# C-17 FLIGHT TEST PROGRAM

**DECISION BRIEF TO PEO  
ON  
USING STATIC WING ARTICLE  
FOR  
LIVE FIRE TEST**

**20 OCT 93**

**C-17 LIVE FIRE TEST AND  
EVALUATION DETAILED TEST PLAN  
HYDRODYNAMIC RAM TEST**

# AIR FORCE-PROPOSAL C-17A WING LEADING EDGE TEST ARTICLE

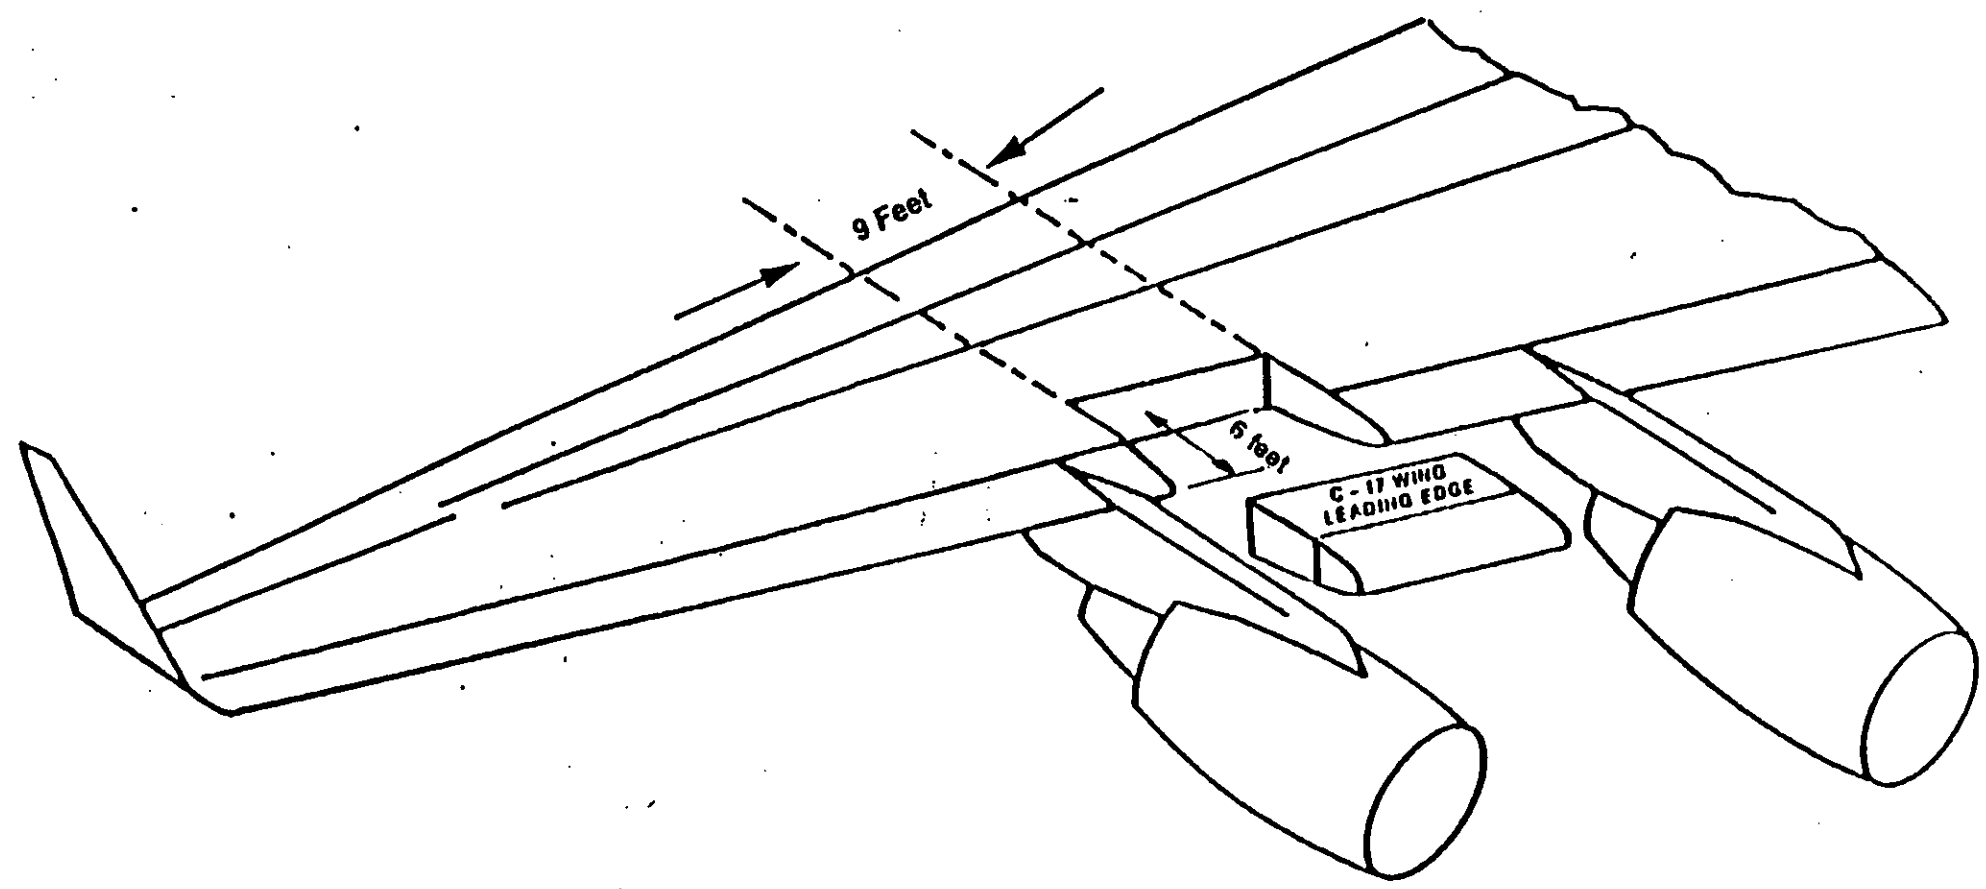
# **ASSESSMENT OF AIR FORCE PROPOSED BALLISTIC TESTS**

- **LIMITED TO 12.7MM API — DESIGN THREAT IS LOW END OF THREAT SPECTRUM**
- **LIMITED TO DRY BAY FIRE ISSUE IN A PORTION OF WING LEADING EDGE —THERE ARE OTHER IMPORTANT ISSUES TO ADDRESS AND OTHER DRY BAYS IN THE WING**
- **TEST ARTICLE IS NOT A PRODUCTION ITEM — SOME RISK OF OBTAINING UNREPRESENTATIVE RESULTS**
